August 18, 2025

Tucker Ferguson
District Engineer, Austin District
Texas Department of Transportation

I-35 CapEx Central Project

Cross-Section of East Avenue Trail at Fiesta Mart / E 40th St, Looking North

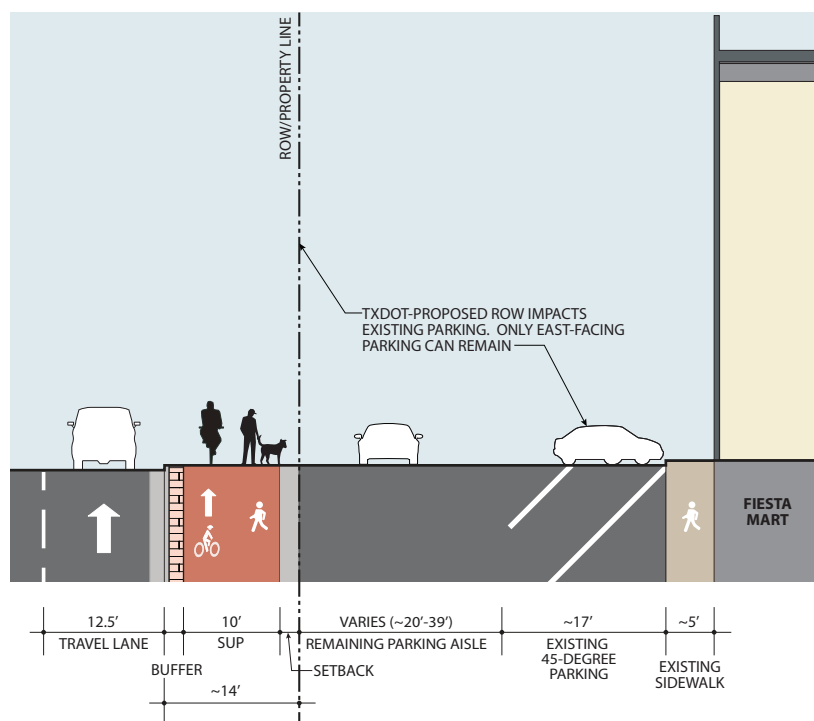
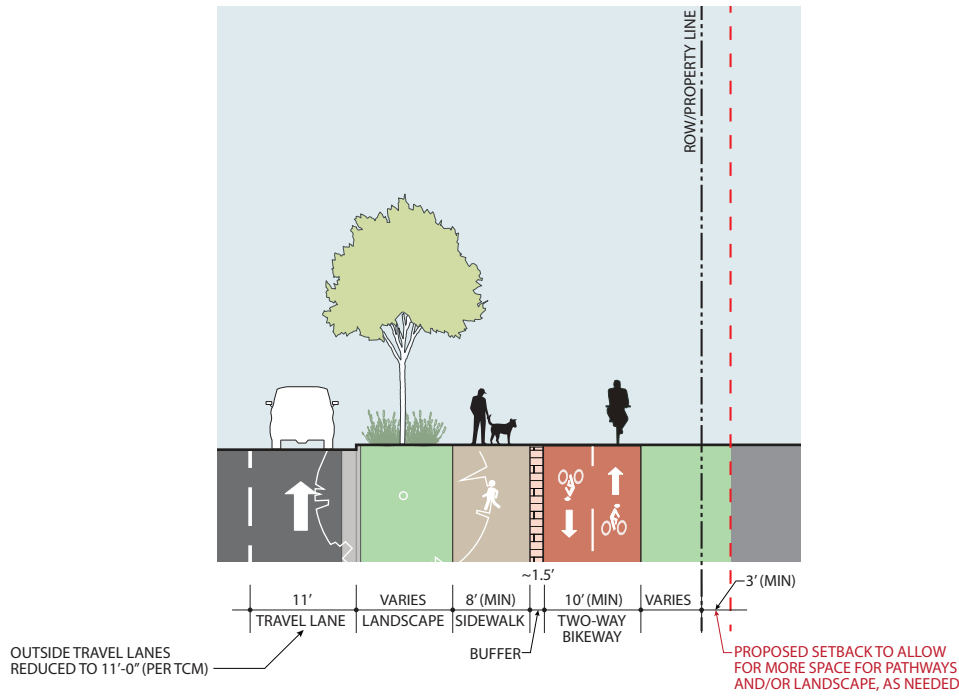
- The TxDOT Design is a cross-sectional depiction of the plan view roll-plots of the 8.5.2025 Design, as posted on the [txdot.gov/mymobility35/projects/capex-central.html](https://www.txdot.gov/mymobility35/projects/capex-central.html) website. As no cross-sections or elevational information were provided, this cross-section is conceptual only.
- A minimum Utility Free Zone of 7' wide X 5' deep is required to allow for shade trees to be planted in a continuous trench, per the Concept Tree Planting Detail found at the end of this package. It is critical to ensure that no underground utilities are located within this zone.
- Trees planted in a continuous trench each require a minimum soil volume of 750 cu ft. Individually-planted trees require a min. soil volume of 1,000 cu ft.

Cross-Sections of East Avenue Trail Concept

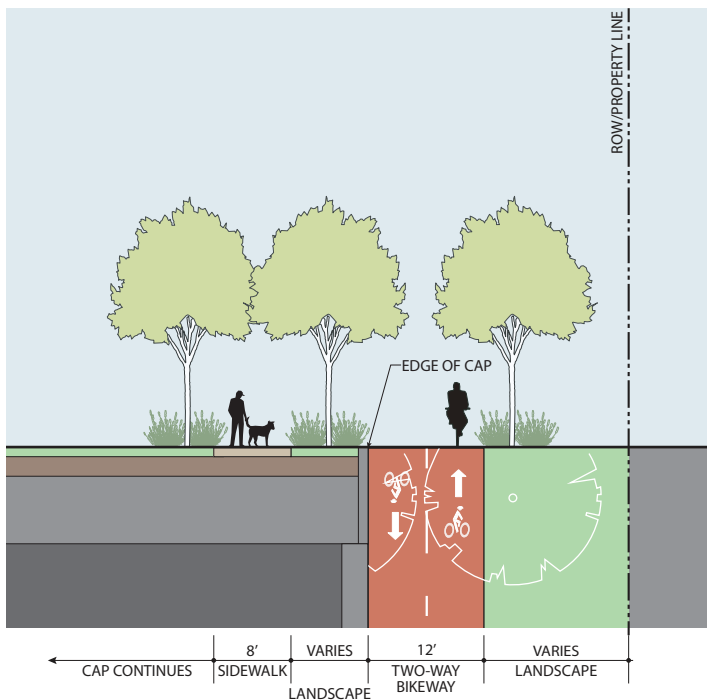
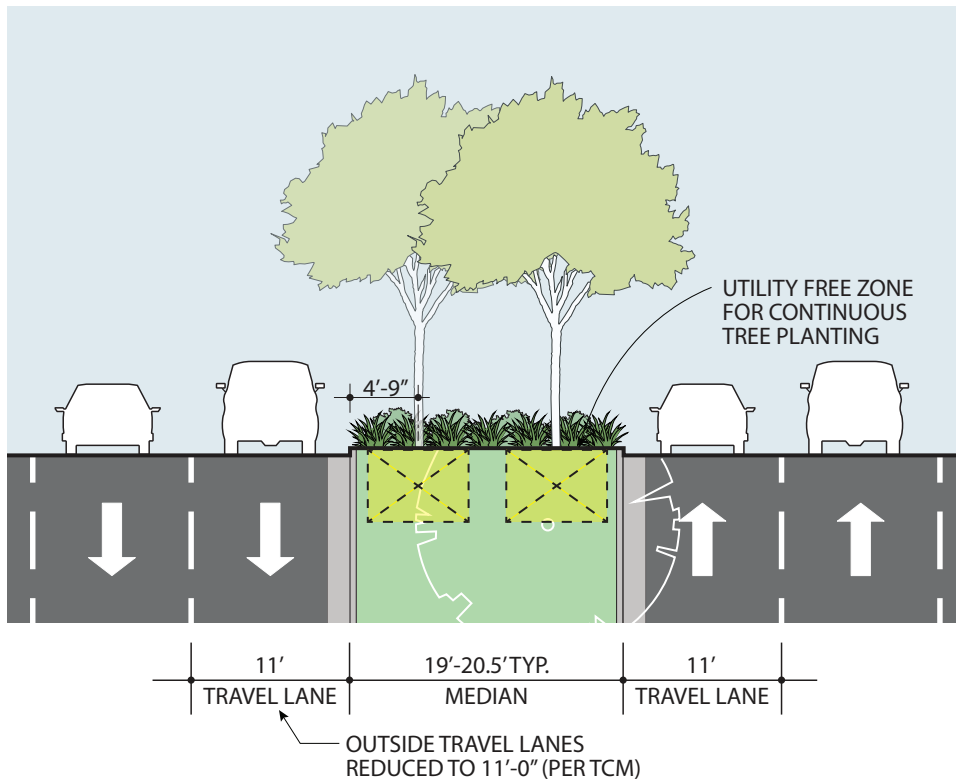
- East Avenue Trail cross-sections are based on the Our Future 35 Vision Plan, dated November 2024.
- A minimum Utility Free Zone of 7' wide X 5' deep is required to allow for shade trees to be planted in a continuous trench, per the Concept Tree Planting Detail found at the end of this package. It is critical to ensure that no underground utilities are located within this zone.
- Trees planted in a continuous trench each require a minimum soil volume of 750 cu ft. Individually-planted trees require a min. soil volume of 1,000 cu ft.

Cross-Section through Median at Frontage Road, Looking North

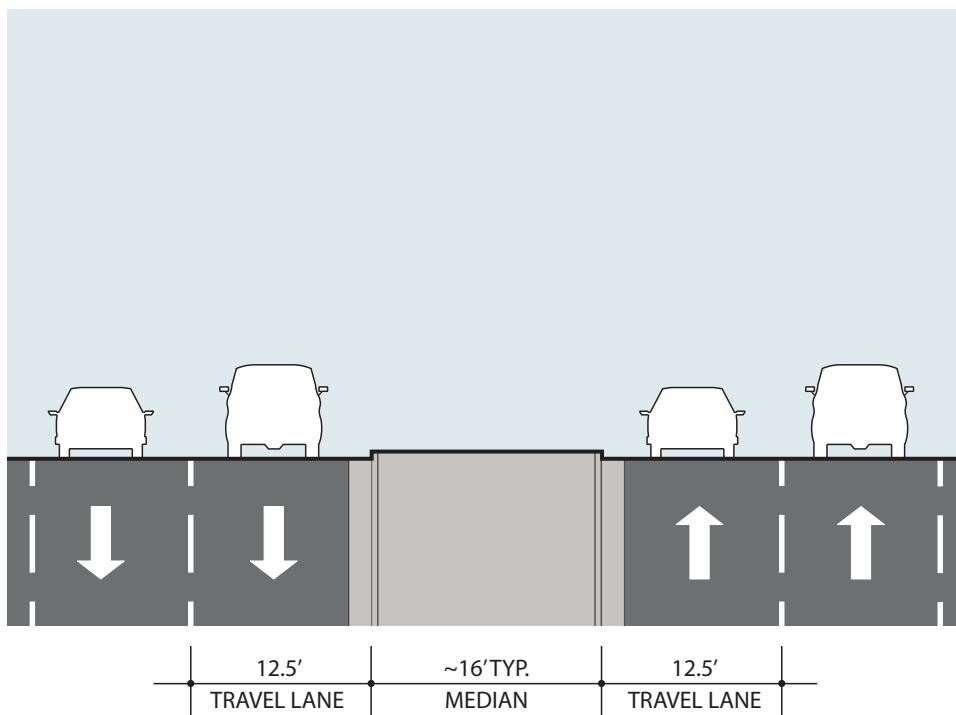
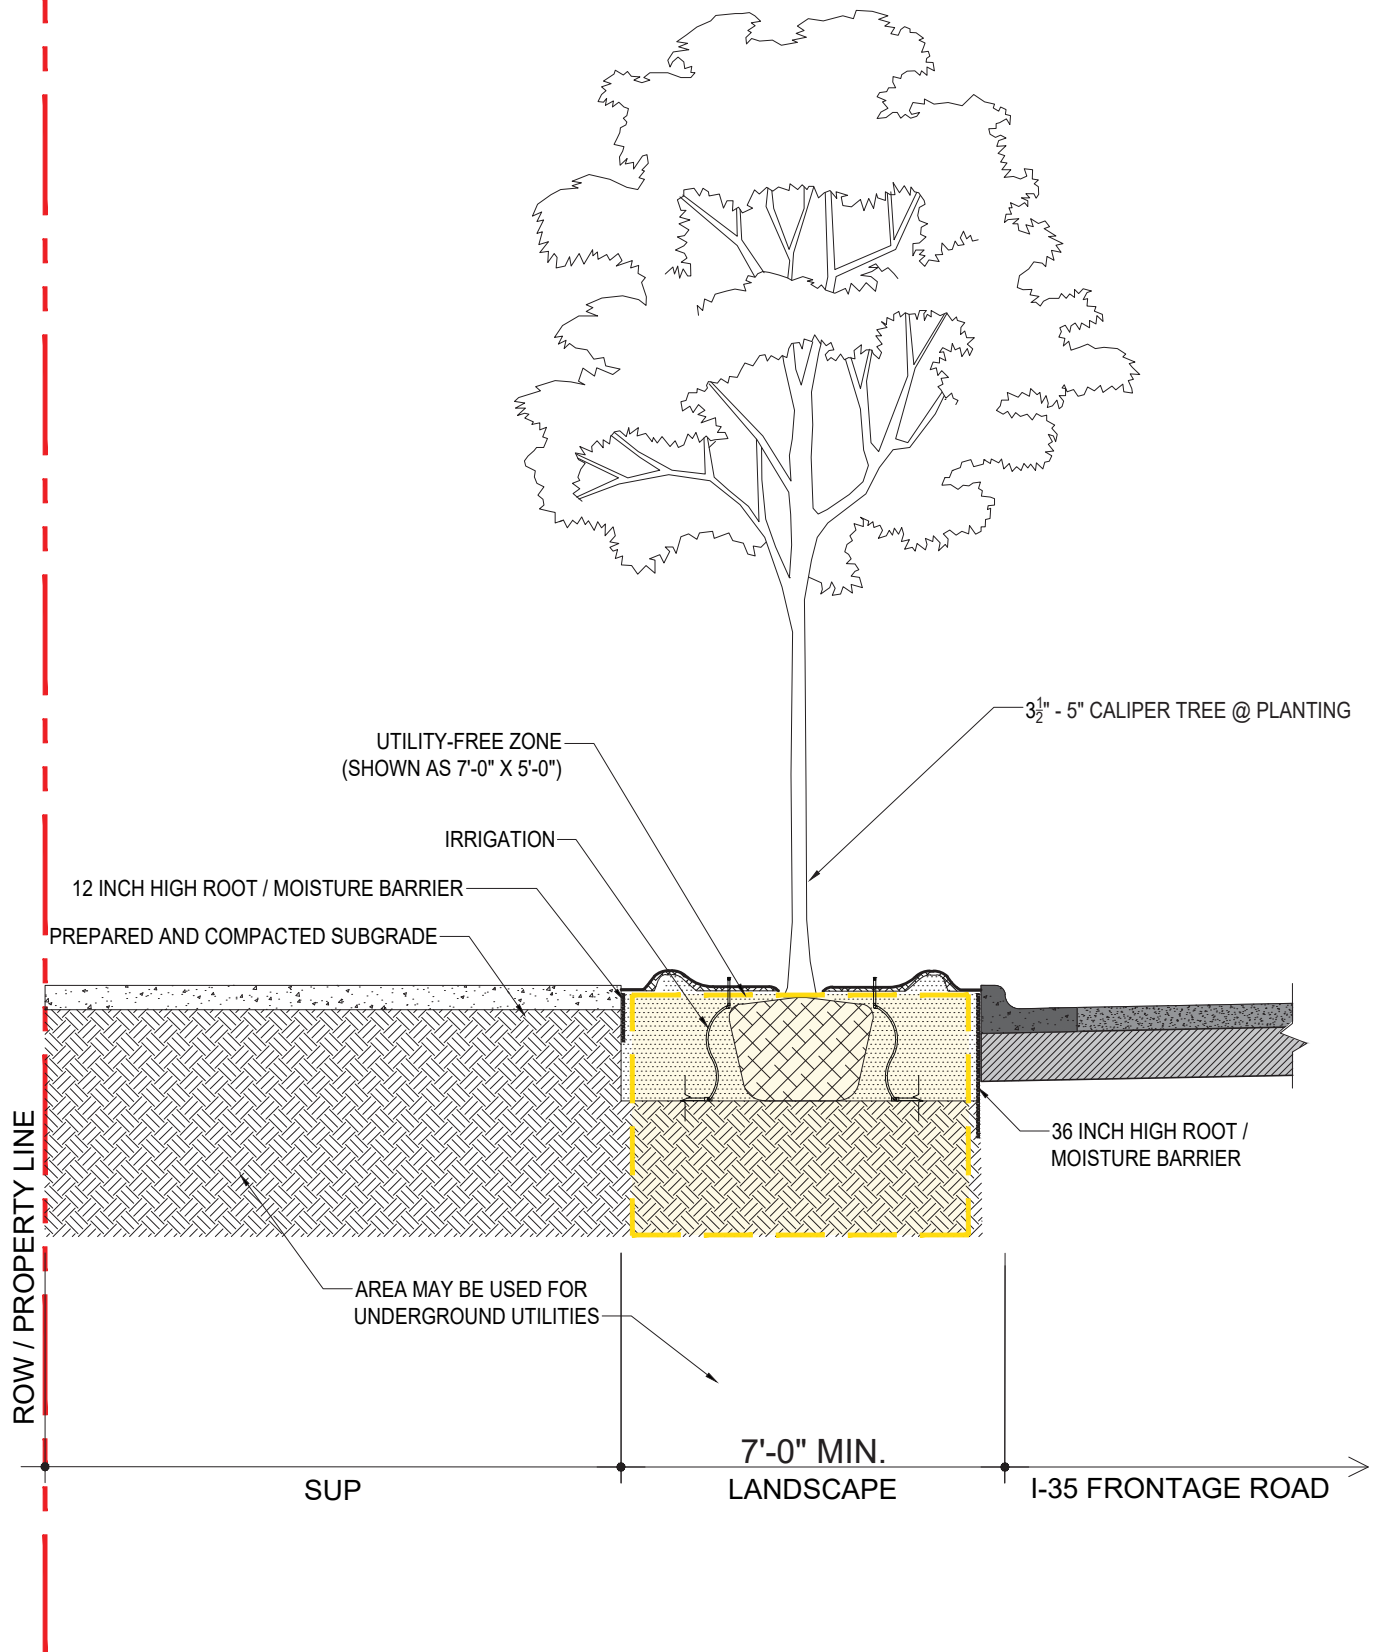
Trees should also be planted in the median of all boulevards.

- The TxDOT Design is a cross-sectional depiction of the plan view roll-plots of the 8.5.2025 Design, as posted on the [txdot.gov/mymobility35/projects/capex-central.html](https://www.txdot.gov/mymobility35/projects/capex-central.html) website. As no cross-sections or elevational information were provided, this cross-section is conceptual only.
- A minimum Utility Free Zone of 7' wide X 5' deep is required to allow for shade trees to be planted in a continuous trench, per the Concept Tree Planting Detail found at the end of this package. It is critical to ensure that no underground utilities are located within this zone.
- Trees planted in a continuous trench each require a minimum soil volume of 750 cu ft. Individually-planted trees require a min. soil volume of 1,000 cu ft.
